## **AW50-40LE/42LE**

PART NUMBER 59954-01K

# Lockup Control Plunger & Sleeve Kit

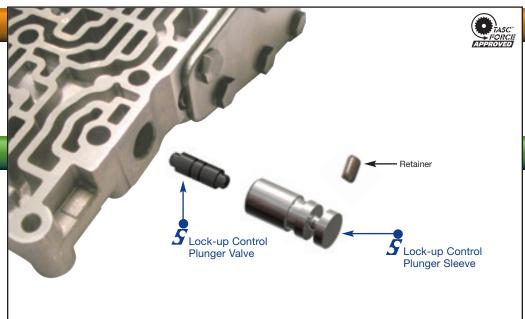
Continuous oscillation of the steel lockup control plunger valve wears the inside of the aluminum sleeve bore, allowing converter apply pressure to exhaust and preventing proper control of the lockup control valve.

A vacuum test of the sleeve assembly (while in the bore at the outboard converter apply feed port as indicated) gives less than 18" of vacuum, or if a Wet Air Test at the same location results in leakage at the neighboring exhaust port.

The tightly toleranced, drop-in replacement Sonnax valve and sleeve assembly restores proper hydraulic clearances and uses upgraded materials to prevent wear.

- No special tools required.
- Sleeve is manufactured from highly wear-resistant billet aluminum.
- Valve is made of hard-coat anodized aluminum to prevent wear.
- Annular grooves have been added to the valve to prevent side-loading and wear.
